CONTRACT NO. 1797

OHIO RIVER TUNNEL

ADDENDUM No. 5

All bidders bidding **Contract No. 1797** shall read and take note of this **Addendum No. 5**. The Contract Documents for **Contract No. 1797 – Ohio River Tunnel** are hereby revised and/or clarified as stated below.

SECTION C-C

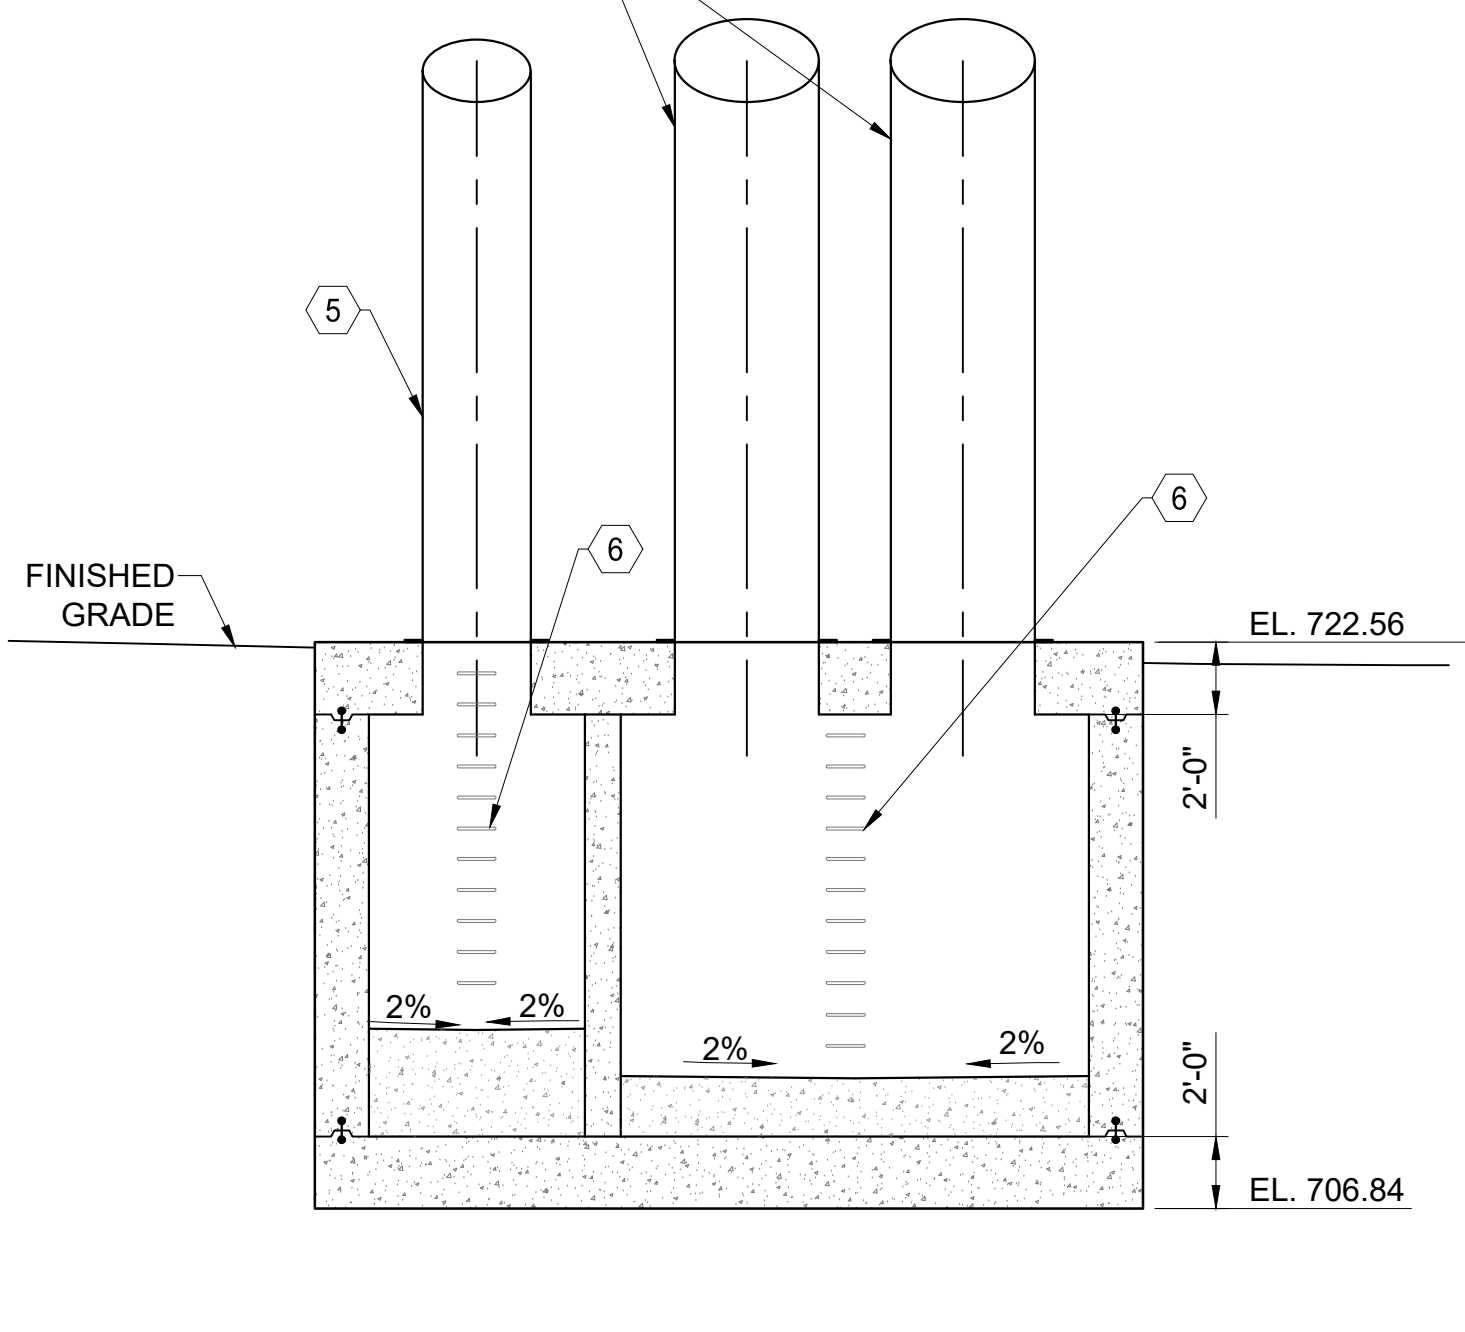
- A2 **This is a dedicated full-time position.**
- Q3 *Ventilation Diffuser SOE - For all sites that contain ventilation diffusers, a support of excavation design is to be designed by the contractor, and submitted to the owner for review and approved. The contract drawings reference in the support of excavation notes under note C, "Any excavation for the ventilation vaults deeper than 4 feet shall be supported by a temporary excavation support system without internal bracing or any elements of the SOE system intruding into the excavation footprint."*

- Please remove these internal bracing restrictions to allow the Contractor and their Engineer to determine the best solution for shoring these excavations.*

- A3 **Drawings O27-ST-142, O27-ST-143, O41-ST-226, A48-ST-315, A58-ST-438, A58-ST-440 O14-ST-628, O07-ST-713, O06A-ST-814, and O06A-ST-815 are revised and attached to this Addendum. See CHANGES TO CONTRACT DOCUMENTS section below and Attachment A of this Addendum.**

- e) DELETE A58-ST-438 (Sheet 439 of 770) and ADD Revised A58-ST-438 (Sheet 439 of 770), which is Attachment A to this Addendum.
- f) DELETE A58-ST-440 (Sheet 441 of 770) and ADD Revised A58-ST-440 (Sheet 441 of 770), which is Attachment A to this Addendum.

A58-CI-400
EXISTING CONDITIONS PLAN

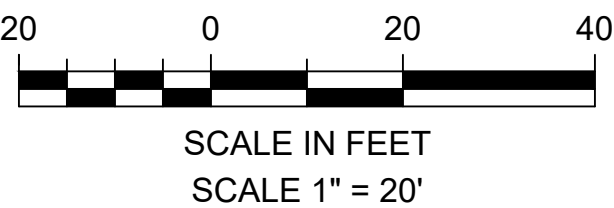
- Q24 *Note 4 on Sheet A58-ST-400 instructs to bypass pump to MH A-58-00. MH A-58-00 location is not identified on the civil plan A58-CI-400. Please provide location of MH A-58-00.*

- A24 **Manhole A-58-00 is shown on A58-CI-400 at the Madison Avenue outfall structure, however the manhole location was not labeled. Drawing A58-CI-400 is revised and attached to this Addendum. See CHANGES TO CONTRACT DOCUMENTS section below and Attachment B of this Addendum.**

- a) DELETE A58-CI-400 (Sheet 386 of 770) and ADD Revised A58-CI-400 (Sheet 386 of 770), which is Attachment B to this Addendum.

Designed by:	REVISION			
	REV No.	DATE	DESCRIPTION	APPV
JRL	1	10/03/25	A-58-00 ANNOTATION ADDITION	SBP
Drawn by:				
MJN				
Checked by:				
DLM
